Item ID: D407-667-205TRN Accept ***N900040100*** Setup Start ***NS1***
Revision ID: Stop ***NS2***
Item Name: Crosstube Turning Detail
Start Date: 2/3/2015 Start Qty: 1.00 ***1*** Cust Item ID:
Required Date: 2/3/2015 Req'd Qty: 1.00 ***1*** Customer:
Reference:

DART AEROSPACE LTD		Work Order: 129301
Description: Crosstube Assembly		Part Number: D407-667-245
Inspection Dwg: D407-667-245 Rev: F		Page 1 of 2

DRAWING NO. D407-667-245	TITLE CROSSTUBE ASSY (407 HIGH AFT)	REV. F	DART AEROSPACE LTD ENGINEERING ORDER		D.E.O. NO. D407-667-245-F-1	SHEET NO. SHEET 1 OF 2	SCALE NTS
DRAWN	CHECKED	MFG. APPR.	APPROVED		DE APPR.		
DATE 11.04.08	DATE 11.04.12	DATE 11.04.12	DATE 11.04.12		DATE 11.04.12

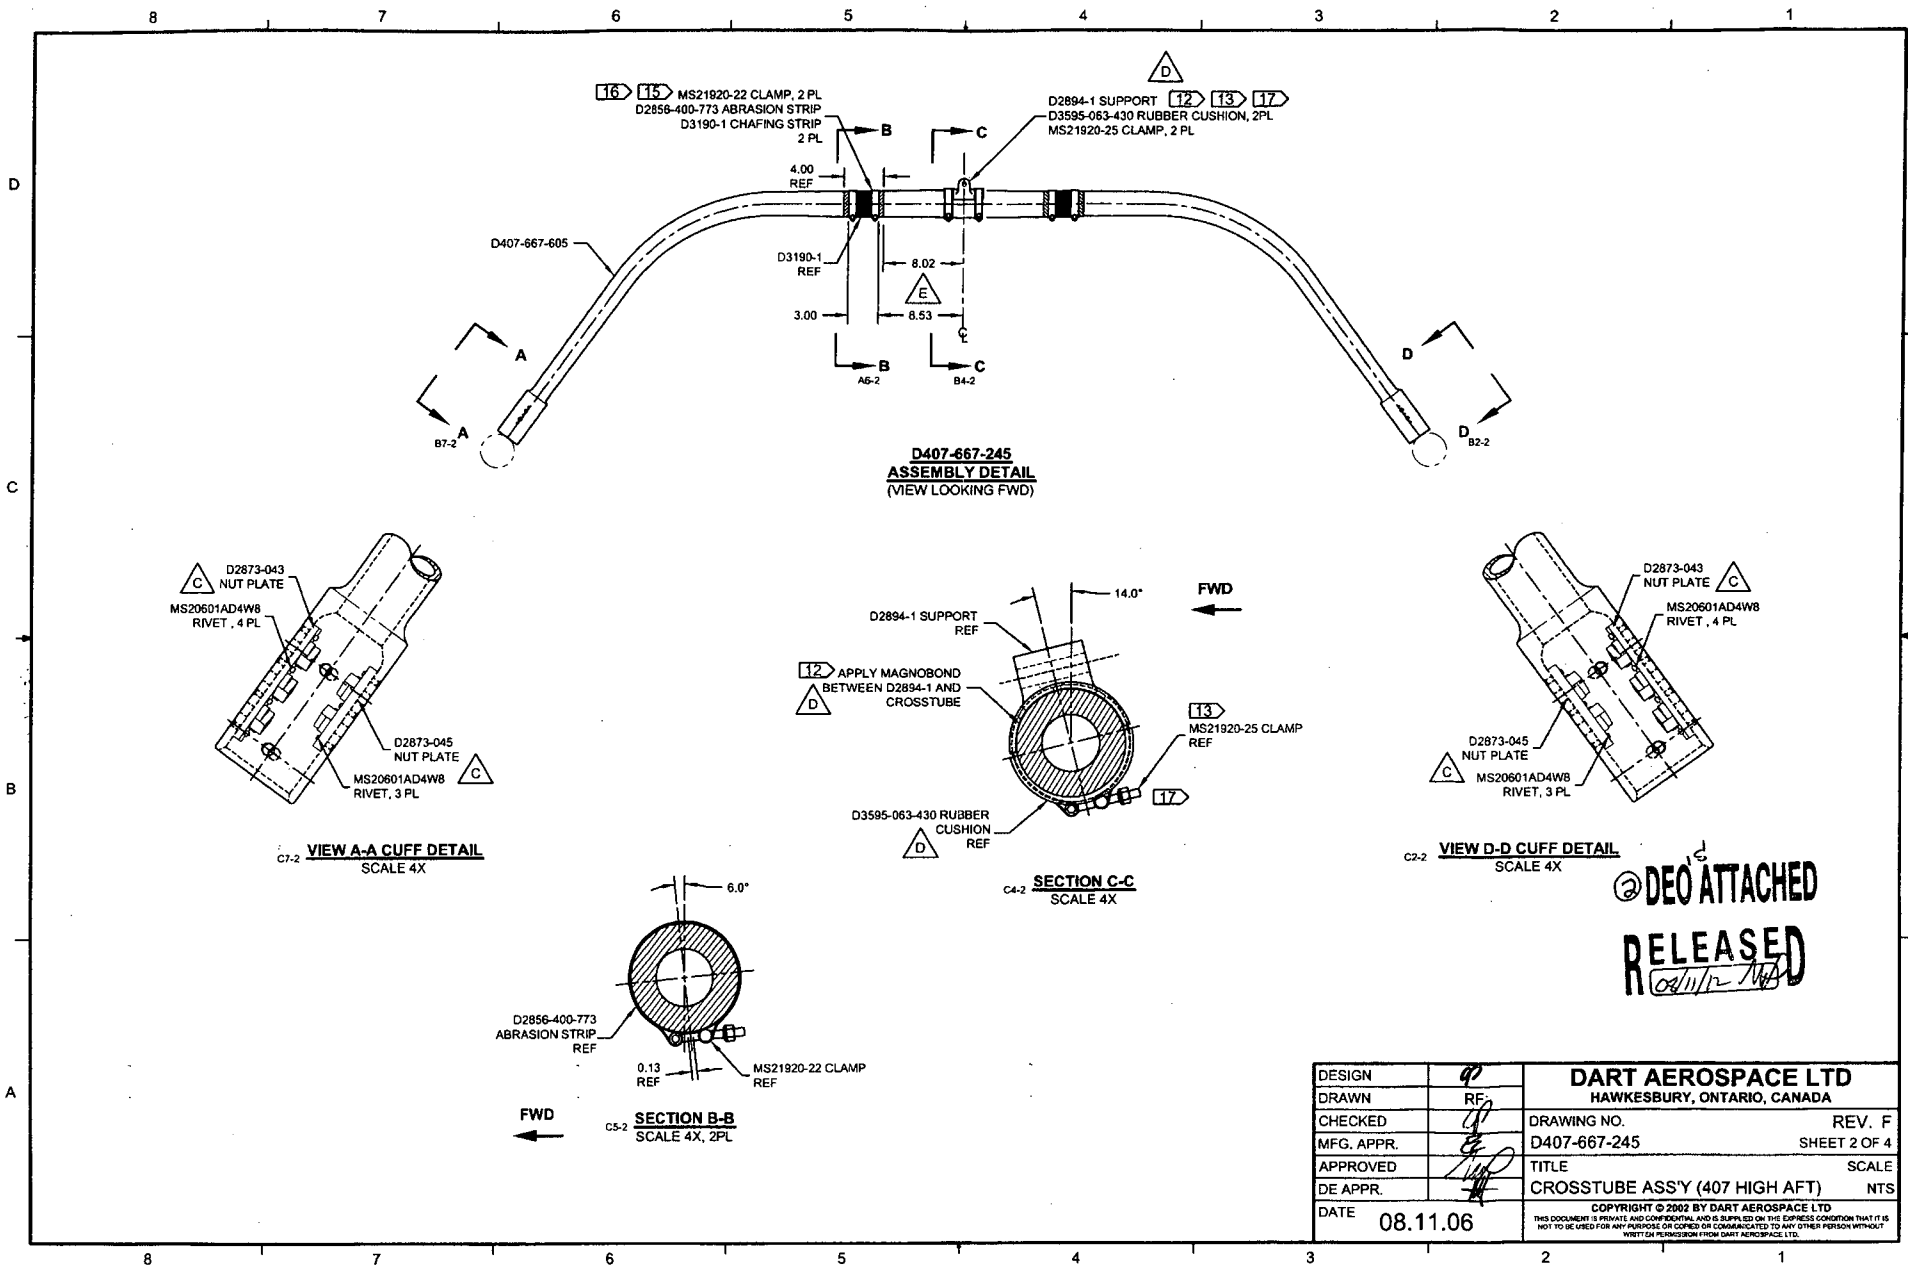
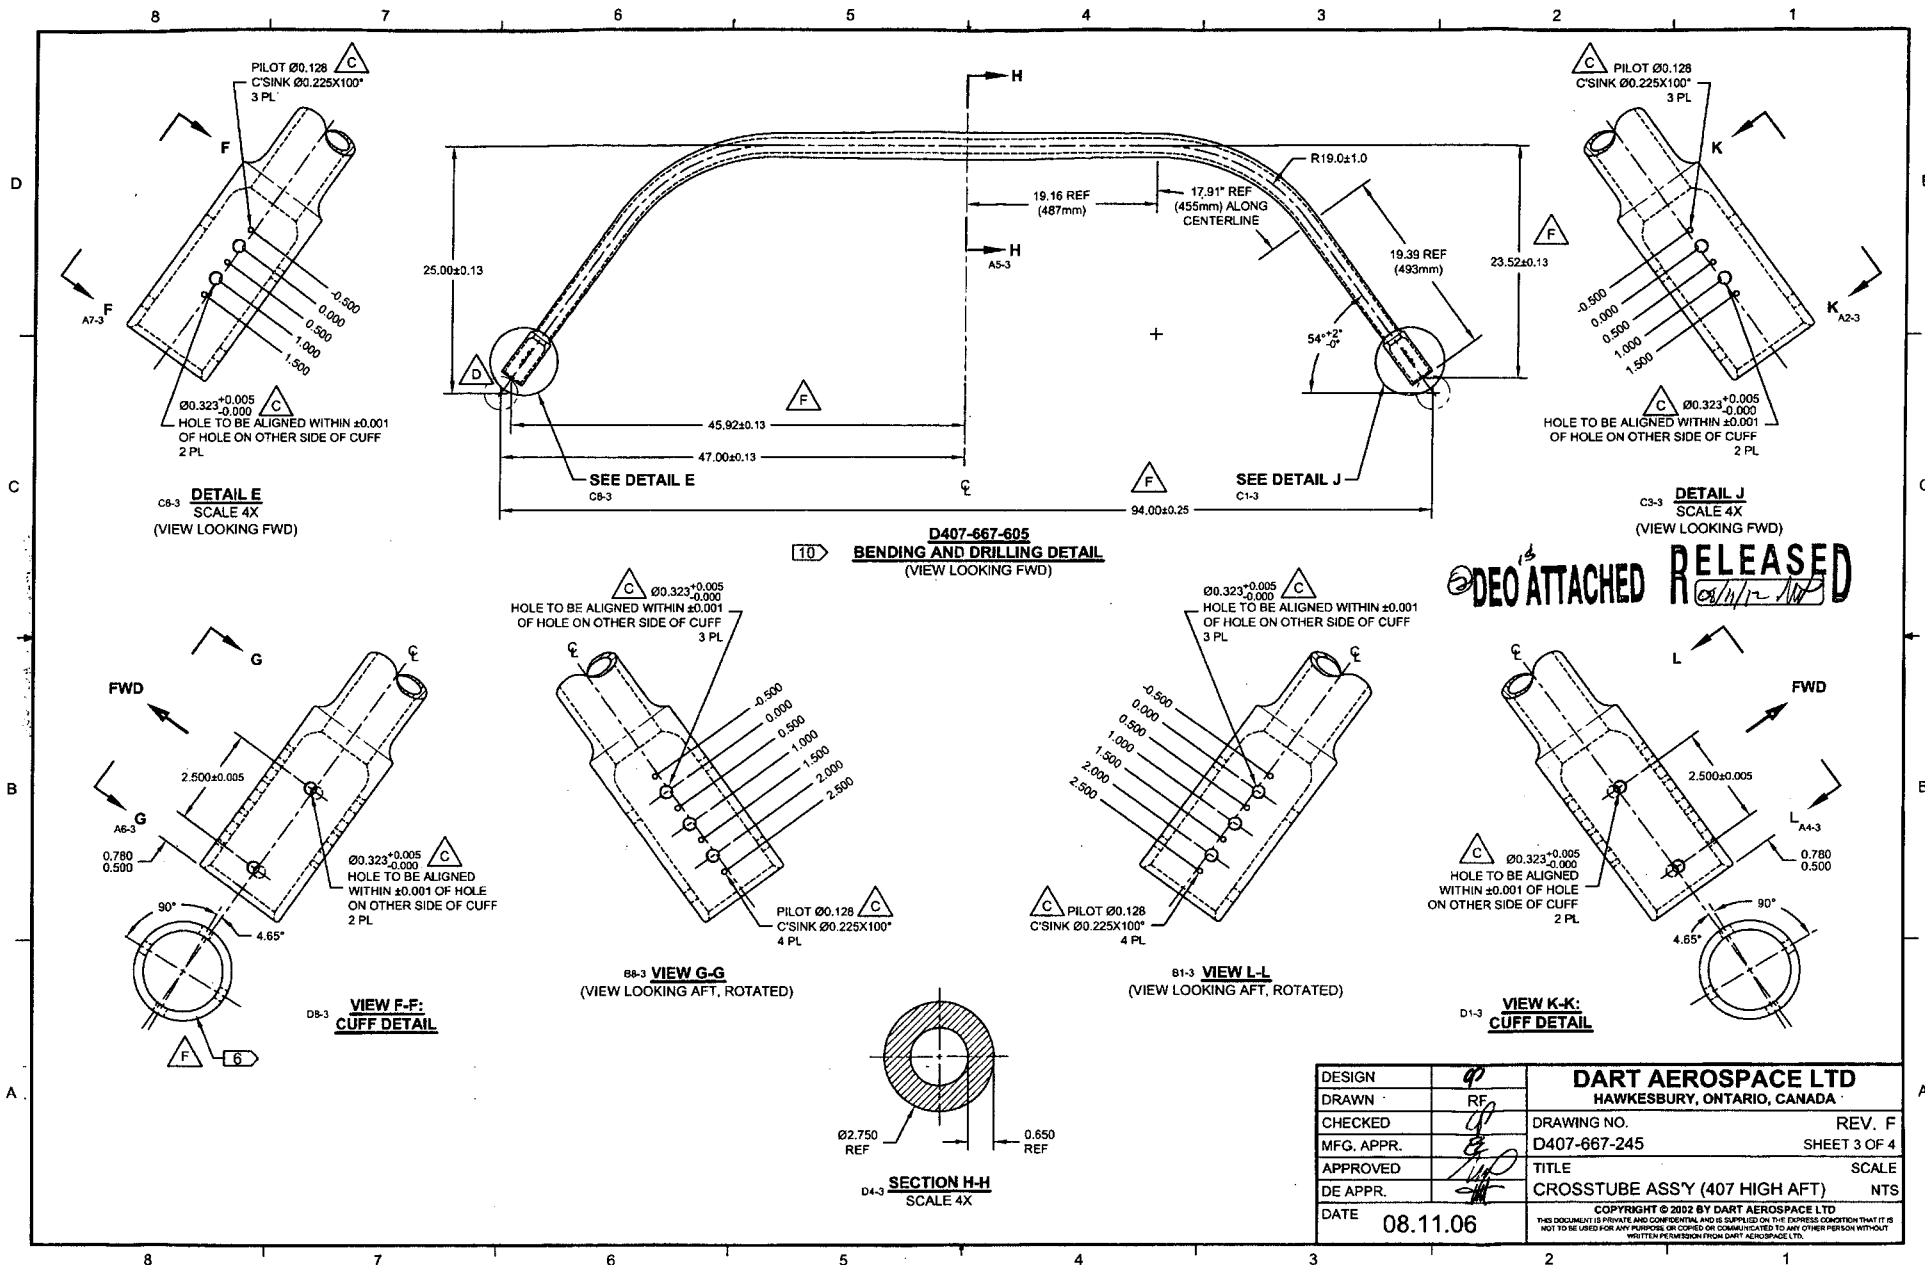
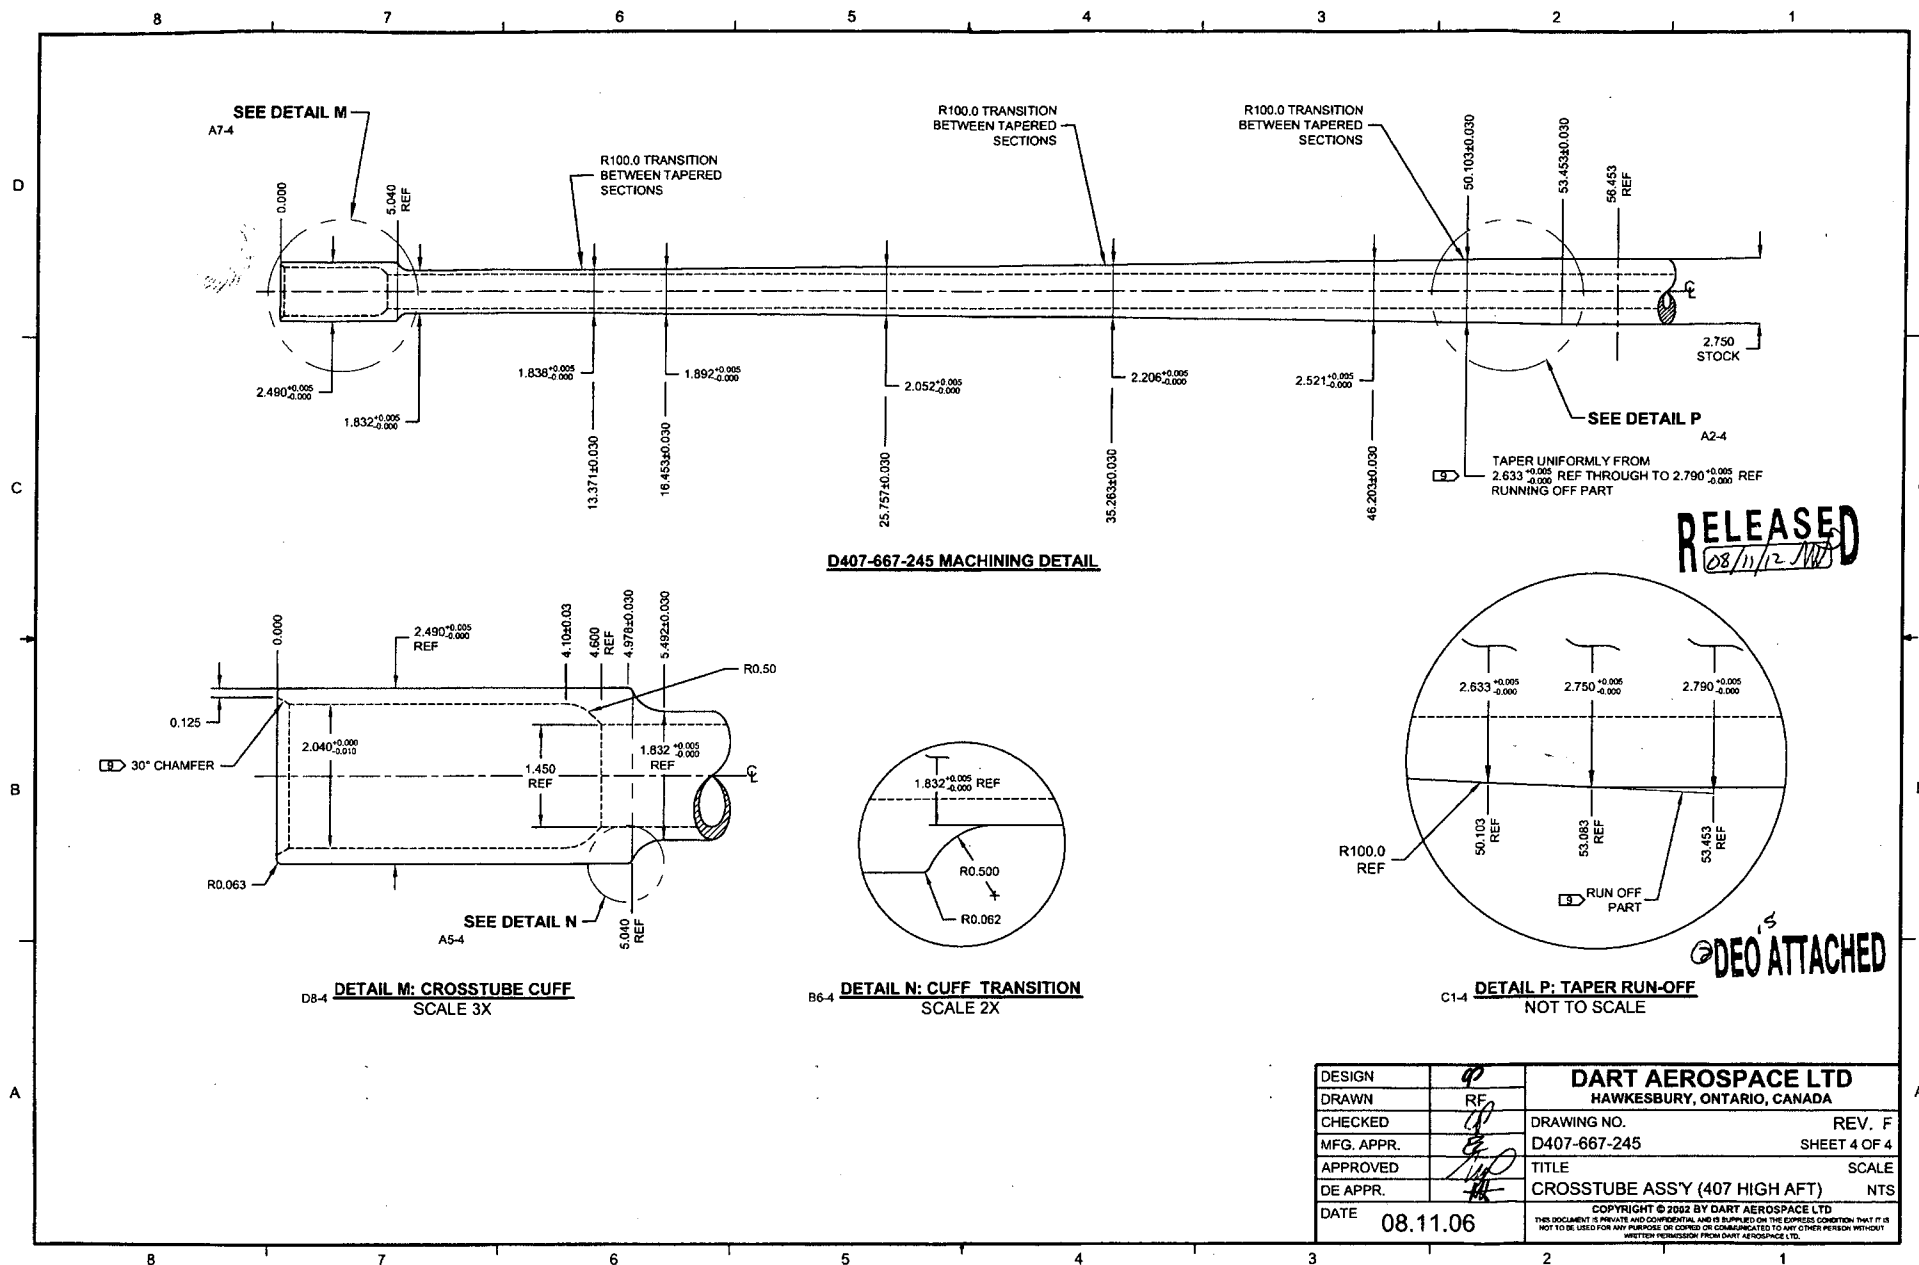
F	REFORMAT NOTES TO NEW STANDARDS (ZN B8-1); RELOCATED FLAG # 6 (ZN A8-3) PER NCR 210; REMOVED REF. & ADD TOLERANCES (ZN C6-3, C4-3 & D2-3)	RF	08.11.06
E	8.02 AND 8.53 WERE 8.40 AND 8.90 (ZN D5-2); REORGANIZED VIEWS AND REFORMATED DRAWING TO CURRENT STANDARDS. REASONS: CLAMPS MOVED 0.375 TOWARD CL TO ELIMINATE INTERFERENCE WITH AIRCRAFT MOUNTS. REFERENCE: FAR#08-21 AND ECR#1225	MB	08.07.24
D	ADD VIEW FOR OEM SKID HOLES, ROTATE ORIENTATION OF CLAMPS SECTION F-F, REMOVE -851 ABRASION STRIP, ADD MAGNOBOND 6398, ADD CUSHION	PH	07.02.07
C	ADD HOLES AND NUT PLATES FOR COMPATIBILITY WITH BHT/AA SKIDTUBES	PH	05.07.26
B	ADD CHAFING SHIELD	CP	03.05.21
A	NEW ISSUE	CP	02.05.13
REV.	DESCRIPTION	BY	DATE
DESIGN	0	DART AEROSPACE LTD HAWKESBURY, ONTARIO, CANADA	
DRAWN	RF		
CHECKED	0		
MFG. APPR.	0		
APPROVED	0		
DE APPR.	0	DRAWING NO. D407-667-245	REV. F SHEET 1 OF 4
		TITLE CROSSTUBE ASS'Y (407 HIGH AFT)	SCALE NTS
DATE	08.11.06	COPYRIGHT © 2002 BY DART AEROSPACE LTD THIS DOCUMENT IS PRIVATE AND CONFIDENTIAL AND IS SUPPLIED ON THE EXPRESS CONDITION THAT IT IS NOT TO BE USED FOR ANY PURPOSE OR COPIED OR COMMUNICATED TO ANY OTHER PERSON WITHOUT WRITTEN PERMISSION FROM DART AEROSPACE LTD.

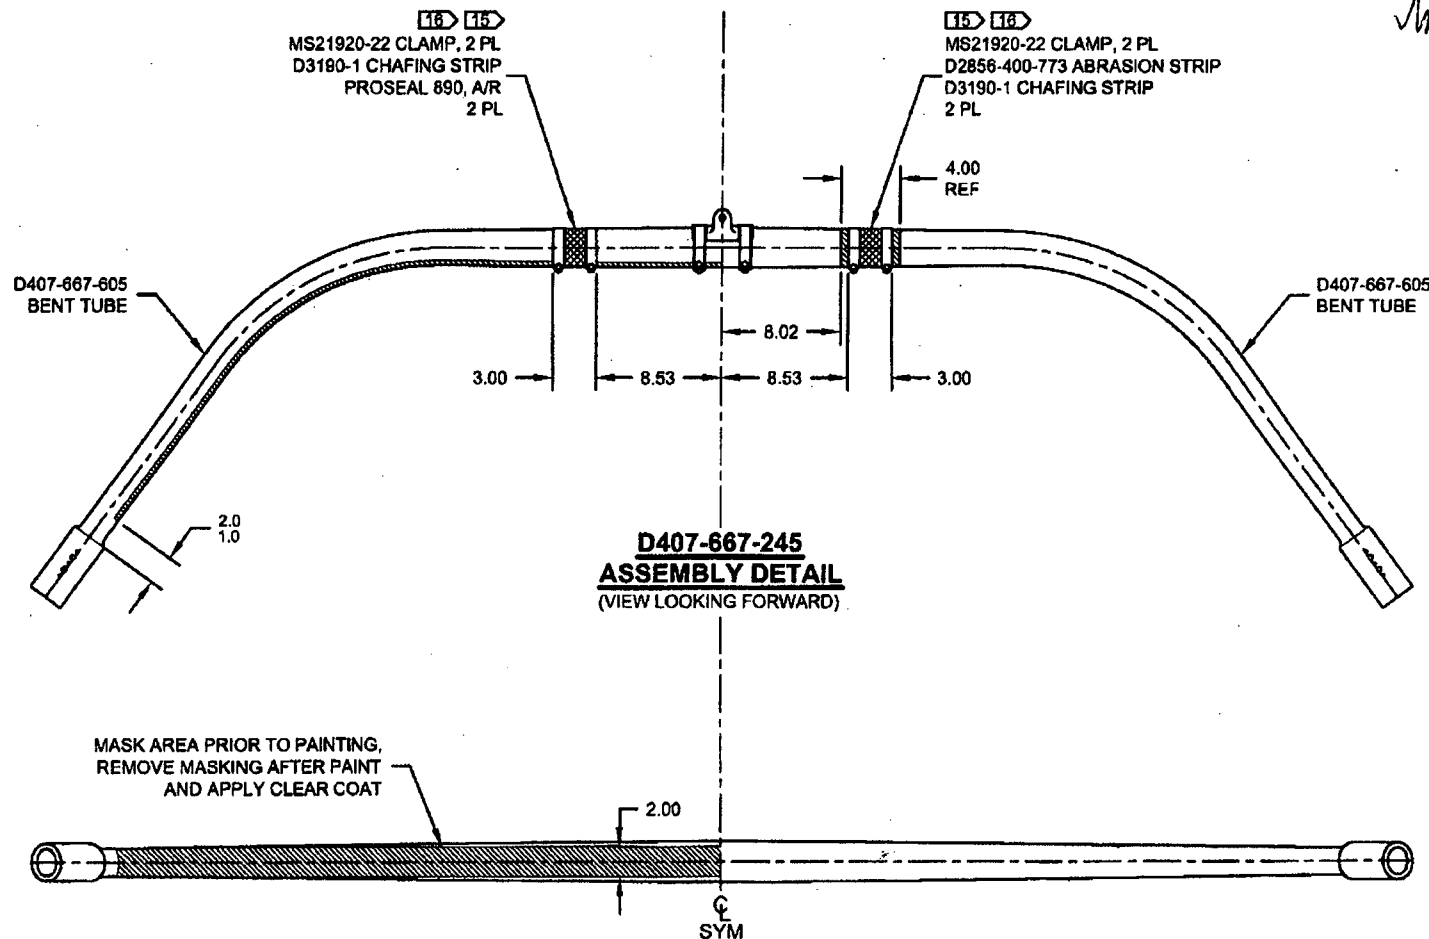
PURPOSE:

REMOVED ABRASION STRIP IN FAVOR OF A THIN LAYER OF PROSEAL 890.

NOTES 2 AND 15, SHEET 1 ARE AMENDED AS FOLLOWS:

- 2) FINISH: CHEMICAL CONVERSION COAT PER DART QSI 005 4.1
PRIME INSIDE AND OUTSIDE PER DART QSI 005 4.2
PAINT OUTSIDE PER DART QSI 005 4.2
- 15) INSTALL D2856-400-773 ABRASION STRIP WITH A 0.13 REF GAP ON BOTTOM SIDE OF
CROSSTUBE PER QSI 035.

Item	Qty -245	Part Number	Description
3	0	D2856-400-773	ABRASION STRIP

- 2) FINISH: CHEMICAL CONVERSION COAT PER DART QSI 005 4.1
PRIME INSIDE AND OUTSIDE PER DART QSI 005 4.2
MASK UNDERSIDE OF CROSSTUBE AS SHOWN (HATCHED AREA) AND
PAINT OUTSIDE PER DART QSI 005 4.2
REMOVE MASKING AND APPLY CLEAR COAT
- 15) APPLY A THIN COAT OF PROSEAL 890 ON INSIDE CONCAVE SURFACE OF D3190-1
CHAFING SHIELDS AND LET CURE PER MANUFACTURER'S INSTRUCTIONS. INSTALL
PROSEALED D3190-1 CHAFING SHIELDS ONTO CROSSTUBE BY APPLYING A THIN COAT
OF PROSEAL 890 ONTO CROSSTUBE. BE SURE TO ELIMINATE ANY AIR GAPS.
